SAFETY ALERT		
Defective B&S OQFRN Range of High Voltage Fuses Number: SA 05/10		
Strategy & Policy Directorate Sponsor: Robin Cawthorne	Date of issue: 05 Oct 10	
Contact if different from above sponsor: Hom Limbu Senior Electrical Engineer Professional & Technical Services Defence Estates, Kingston Road, Sutton Coldfield B75 7RL 94421 3214 / 0121 311 3214		
Email: hombahadur.limbu@de.mod.uk Who Should Read this: CEstOs, Top Level Budget Holders, Prime Contractors, Private Finance Initiatives, Public, Private Partnership and other traditionally procured contracts, Site Estate Authority Teams and Property Managers with responsibility for MOD projects and Property Management Works Services (including the legacy work of EWCs/WSMs), Coordinating Authorising Engineers, Authorising Engineers Electrical, Authorised Persons Electrical, purchasers and installers of final electrical distribution equipment.

Photograph showing striker pin ejection in opposite direction to that indicated on fuse body.

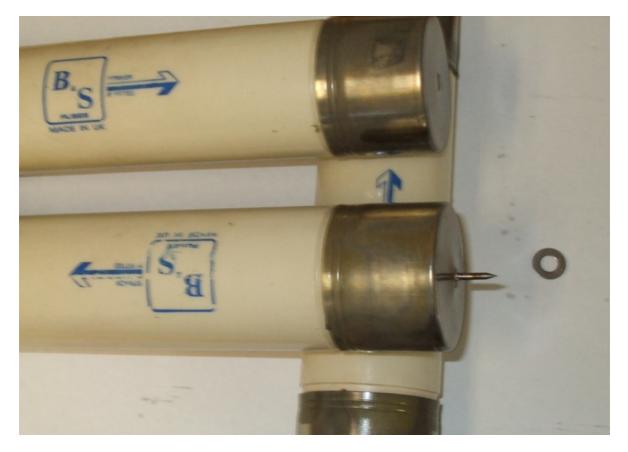
Product	High Voltage B&S Fuse Links – OQFRN range
Manufacturer/Supplier	B&S (now Cooper Bussmann (UK) Ltd)
Problem	Striker pin ejected, but at opposite end to indication on fuse body (see photograph below), so did not trip the Reyrolle ROKS switch that the fuse was fitted to.
Scope	This type of fuse is usually installed in oil-filled Ring Main Units (RMU). Manufacturers of such RMU include Reyrolle, Lucy, Long Crawford, Yorkshire Switchgear and South Wales Switchgear.
Risk	Switch will not trip on downstream faults thus relying on the upstream protection to operate with consequential wider supply disruption
Action	During annual maintenance of the RMU check the fuses to ensure they are correctly installed with the striker pin pointing in the correct direction.
	This should be carried out by visually checking that the arrow on the label points to the end cap with the counter-bore (approx 12 mm in diameter). On the more modern fuses the counter-bore may be a protrusion on the end cap rather than forming a depression.

- a. Dangerous Incident Notice (DIN) 2010/0057/00 notified the following incident:
- b. HV fuse (type OQFRN) operated. Striker pin ejected, but at opposite end to indication on fuse body, so did not trip the switch (Reyrolle ROKS).

- 3. Requirement:
  - a. This Safety Alert has been raised in response to DIN 2010/0057/00.
  - b. Addressees of this Safety Alert are to bring its contents to the attention of their Authorising Engineers (Electrical), or equivalent, who are required to take appropriate action.
  - c. Although the B&S OQFRN fuses are no longer manufactured they will still be widely in use.
  - d. Where incorrectly marked B&S OQFRN fuses are found, the manufacturer will provide free replacement fuses (fully interchangeable Cooper Bussmann OEFMA range). The manufacturer can be contacted as follows:
